Stormwater Quality Plan Information Sheet and Inspection Fee Schedule

Project Name: Coors & Western Trail Tract 3A

Mr. James D. Hughes, P.E.
Principal Engineer, Planning Department
PO BOX 1293
Albuquerque, NM 87103

**RE: RESPONSE TO STORMWATER QUALITY COMMENTS
ATIVO ALBUQUERQUE LLC – 4500 QUAKER HEIGHTS
EROSION AND SEDIMENT CONTROL PLAN**

ENGINEER'S SEAL	DRAWN BY RG
RONALD R. BOHANNAN NEW MEXICO 7868 PROFESSIONAL ENGINEER	DATE 05/17/2021
TIERRA WEST, LLC 5571 MIDWAY PARK PL NE ALBUQUERQUE, NEW MEXICO 87109 (505) 858-3100 www.tierrawestllc.com	DRAWING 2019064-SWPPP
RONALD R. BOHANNAN P.E. #7868	SHEET # SW-1
	JOB # 2019064

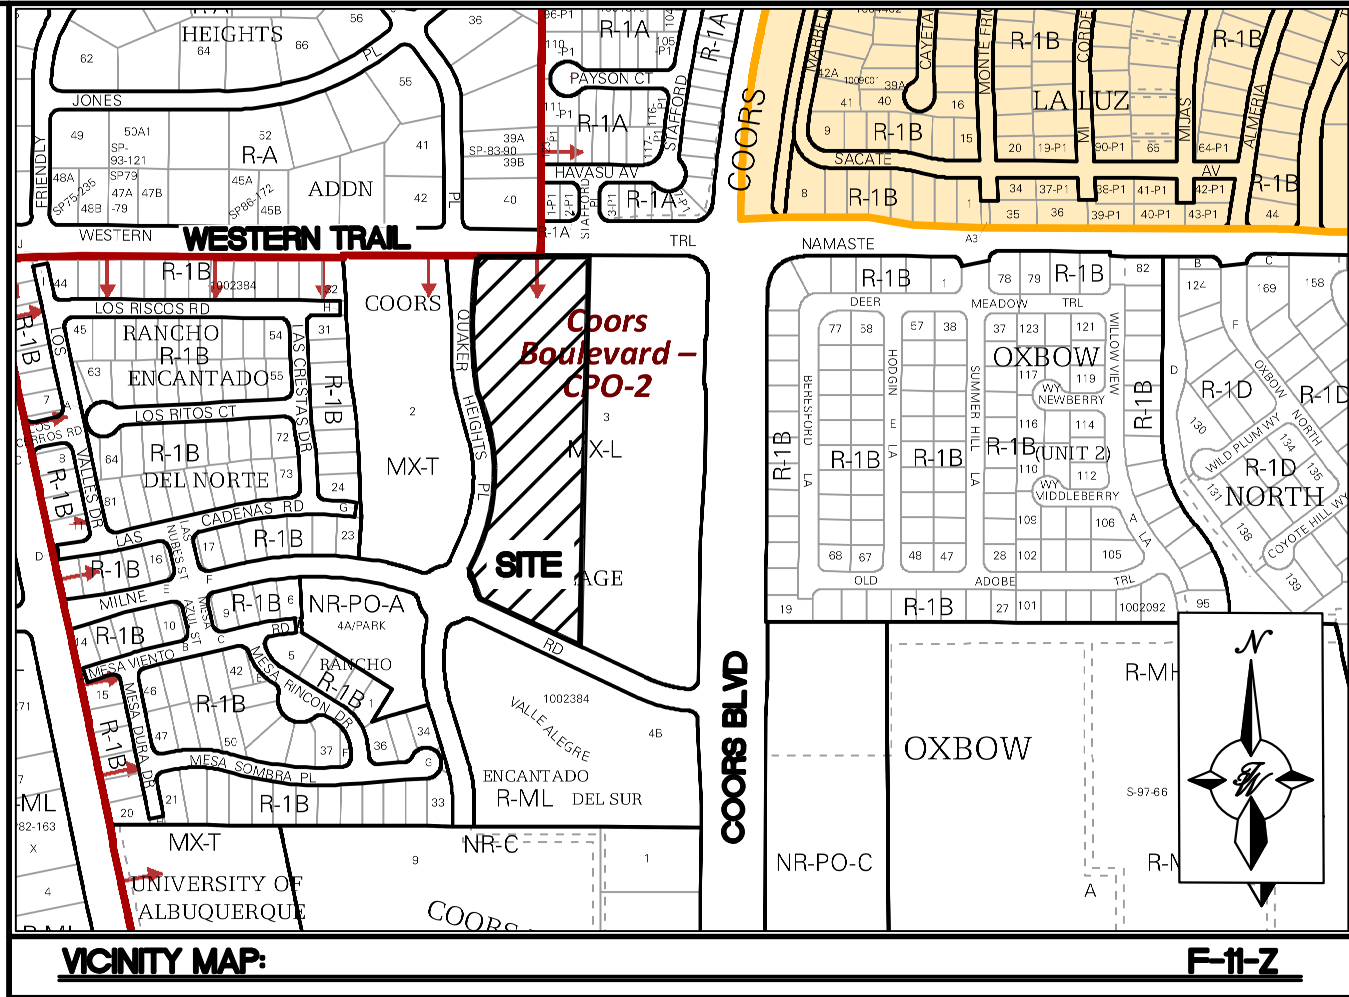
1. The "limits of disturbance" symbol in the legend is not shown anywhere on the plan. Clearly indicate the limits of disturbance. (CGP7.2.4.b.i)
Response: The limits of disturbance are now shown on the plan with line work matching that of the legend.

Response: The site plan is being included in this ESC Plan resubmittal package.
3. Describe undisturbed and pre-construction ground cover (CGP7.2.4.e)
Response: A "Undisturbed and Pre-Construction Ground Cover" note has been added to the plan for describing existing ground cover.

4. List operators on the plan, including name, phone #, and e-mail address. Include the developer/property owner's representative authorized to make changes to contract documents, plans, and specifications per CGP 7.2.1. If there are multiple operators describe the area of control for each. State whether the operators will share a SWPPP or if they will each have separate SWPPPs

Response: The operators (the owner and contractor) are now listed on the plan with contact information.
5. Identify stormwater team members responsible for sediment removal, BMP maintenance, and inspections on the plan, including name, phone #, and e-mail address (CGP 7.2.2). Provide the stormwater team for each operator

Response: A stormwater team members list has been added to the plan with contact information.
6. Describe the nature and extent of construction activities for each operator (CGP7.2.2.), including a) nature of construction activities, b) size of the property, c) size of disturbed area, d) description of construction support activities, and e) size of maximum disturbed area.

8. Soil information – add a table with name type, particle sizes, and Erodibility factor (CGP 2.1.1).

9. Update the engineer's stamp date each time the plan is changed.

10. City Standard ESC Notes attached.

Response: This information has been added to the plan.

Response: A soil information sheet has been added to the plan for providing this information.

Response: The engineer's stamp date has been updated for this most recent resubmittal.

Response: These notes have been added to the plan.

TRACT 3A COORS VILLAGE 4500 QUAKER HEIGHTS AVE NM 87120	DRAWN BY RS
	SITE PLAN FOR BUILDING PERMIT	DATE 6/24/2020
		2019064_SP
		SHEET # C1
 5571 MIDWAY PARK PLACE NE ALBUQUERQUE, NM 87109 (505) 858-3100 www.tierrowestllc.com		JOB # 2019064

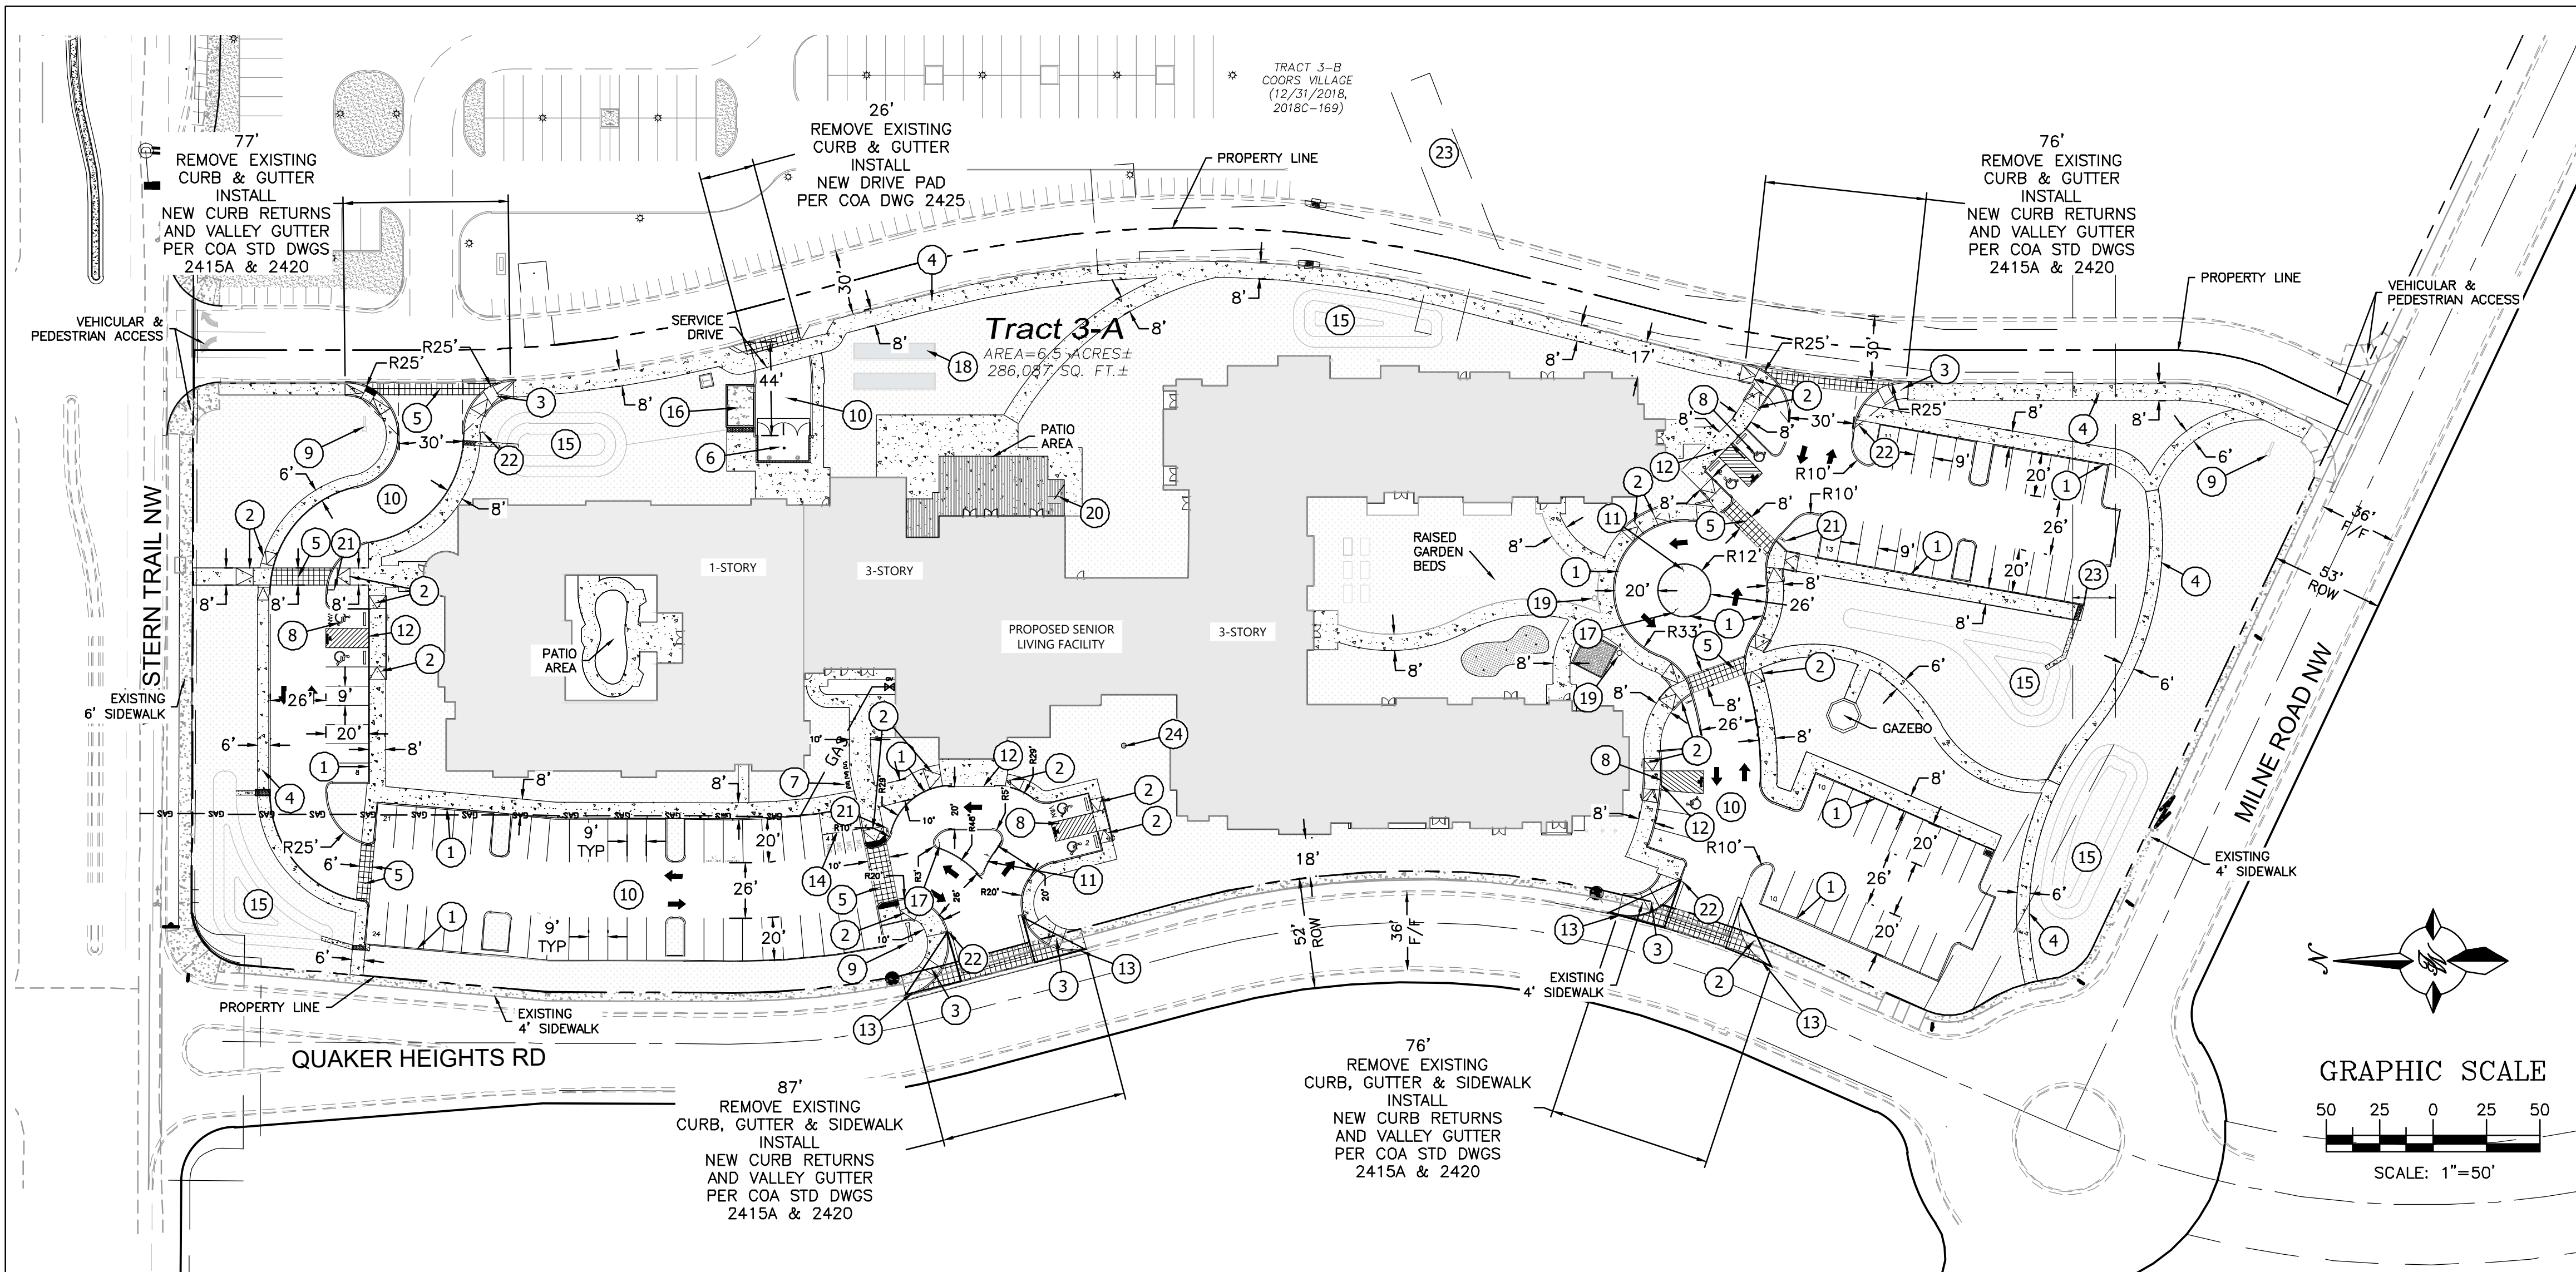
2. The locations of structures and other impervious surfaces. (CGP7.2.4.b.v). The Site Plan can be used to satisfy this requirement and should be included in the SWPPP and the ESC Plan submittal.

OVERALL
PLAN

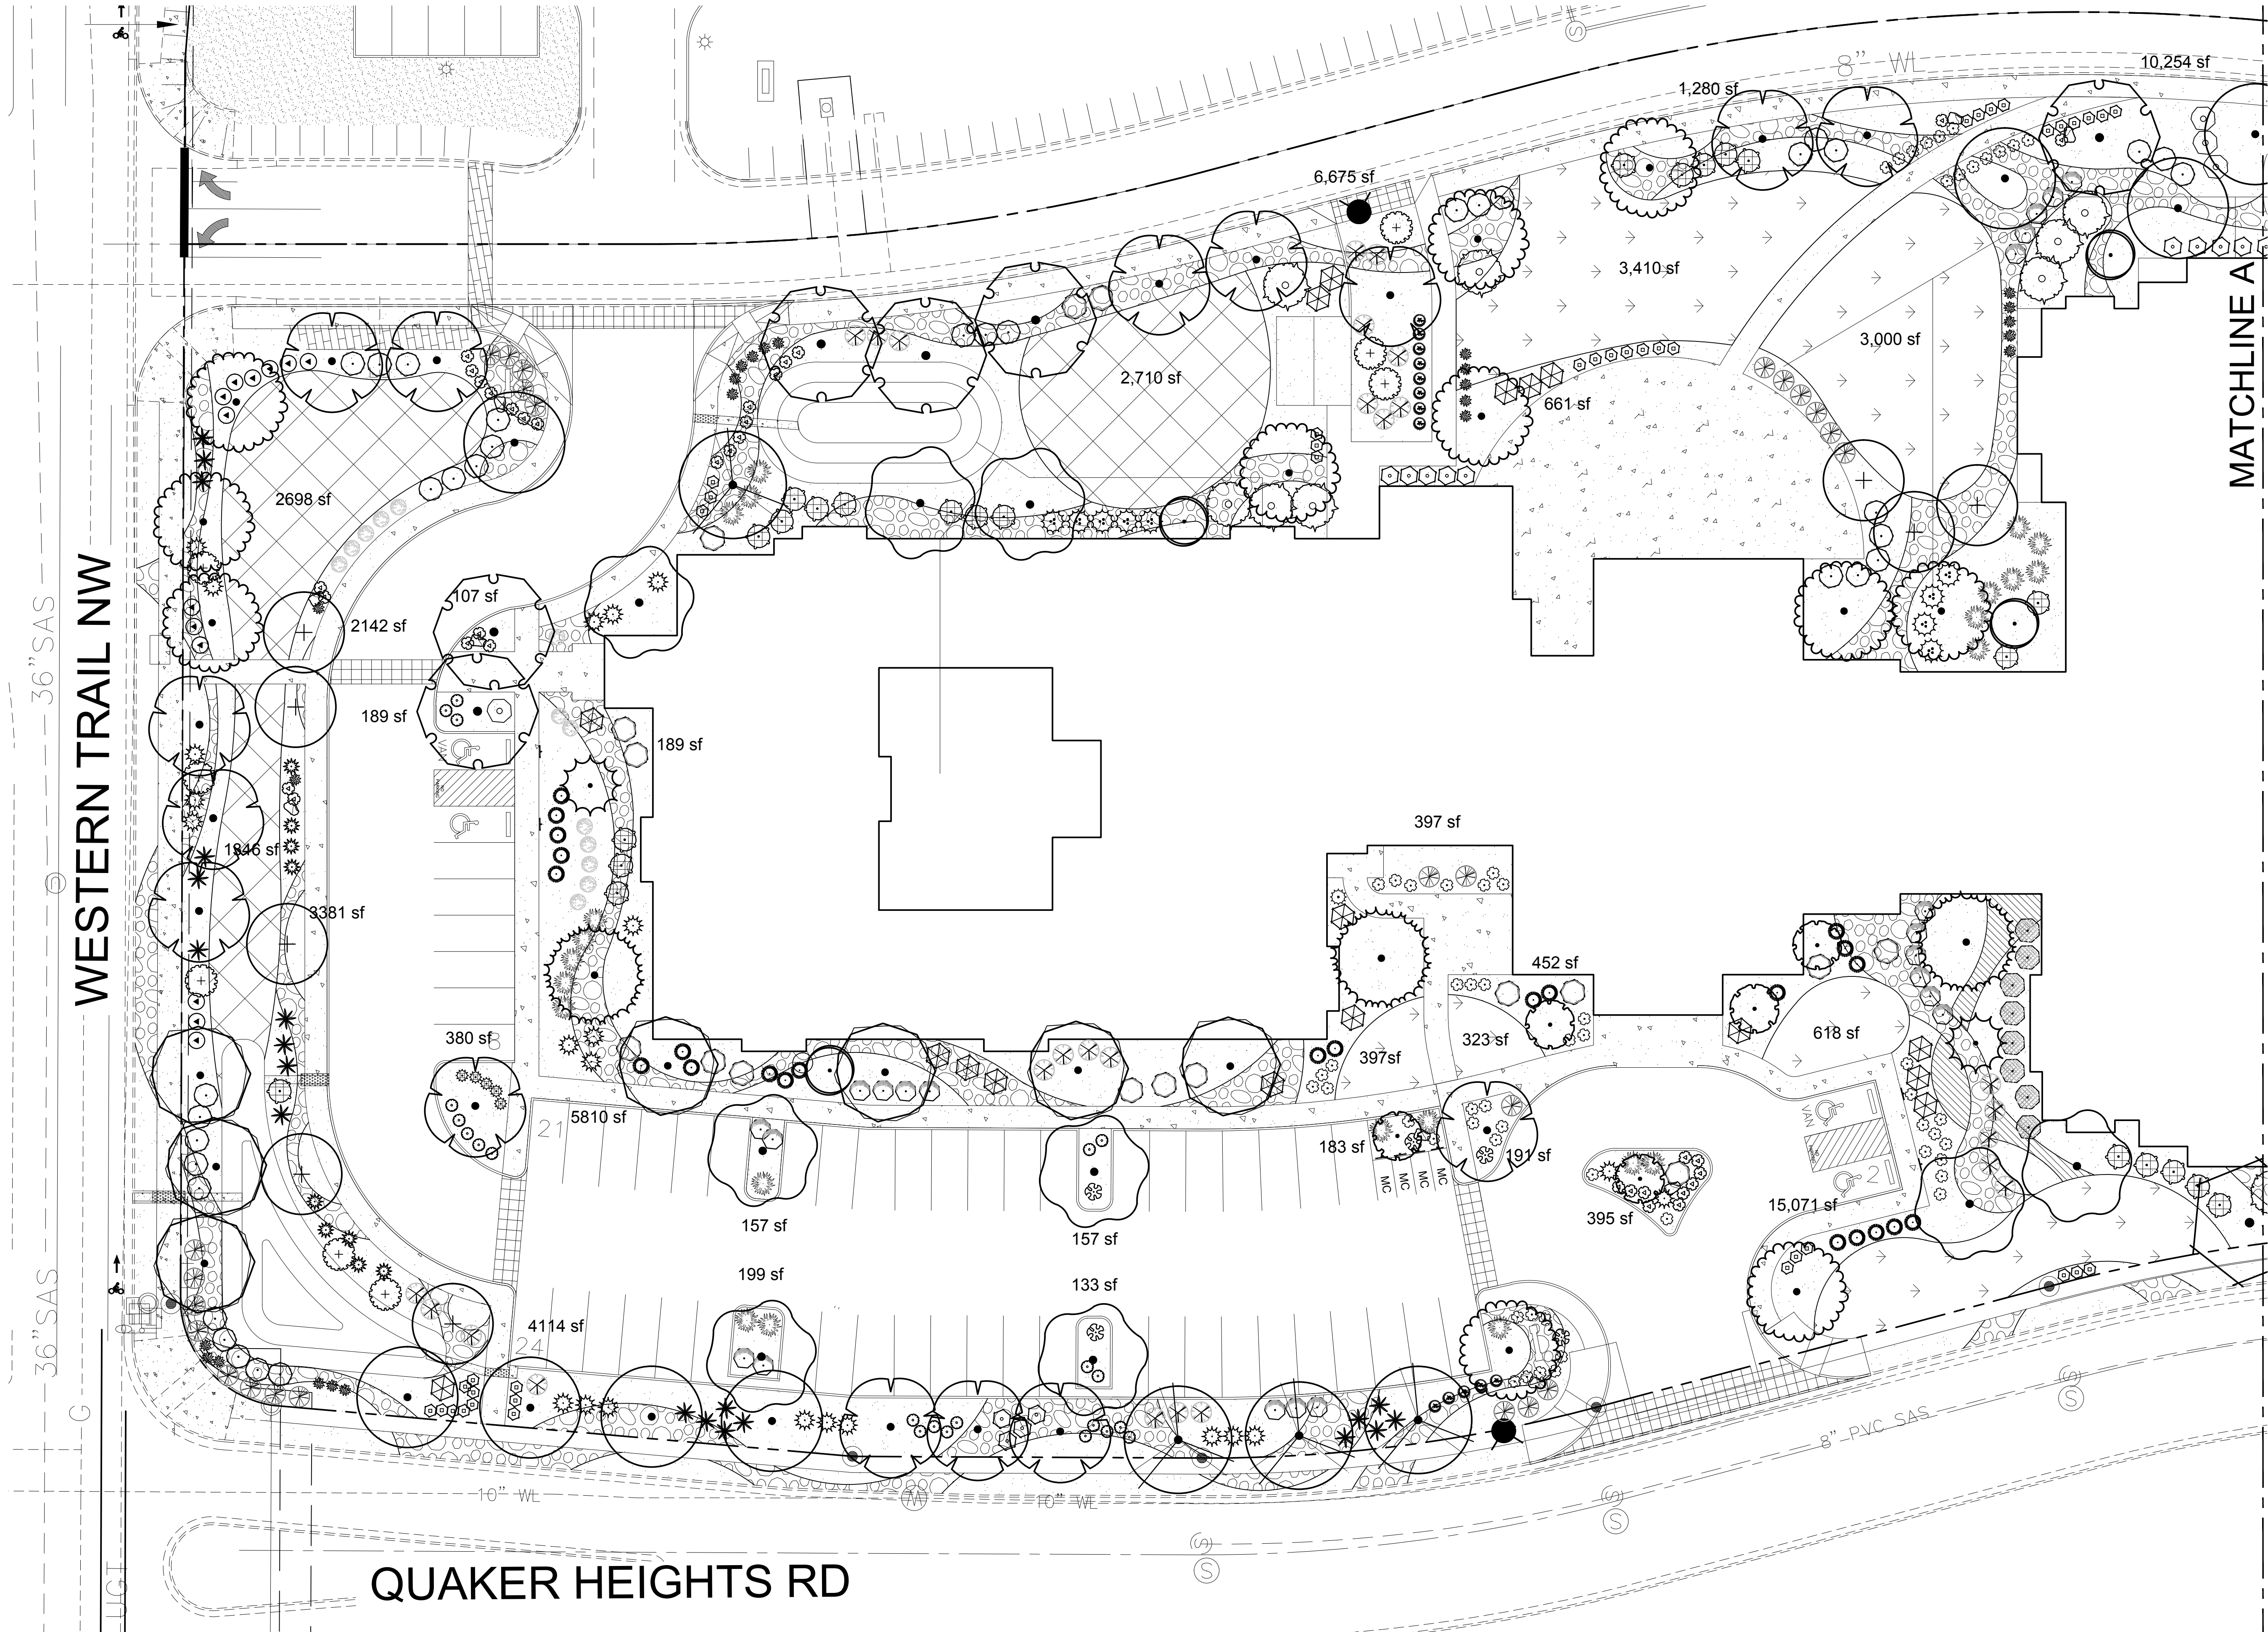
7. Stabilization measures (CGP 7.2.6.b.vi), including a) Specific vegetative and nonvegetative practices, b) deadlines, c) beginning and ending dates of the seasonably dry period, d) procedure to comply with The Weed Removal Ordinance (§ 9-8-1). The landscape plan can be used to satisfy this requirement and should be included in the SWPPP and the ESC Plan submittal. It should include the street right of way adjacent to the site.

Response: The landscape plan is being provided with this ESC Plan resubmittal to satisfy this requirement.
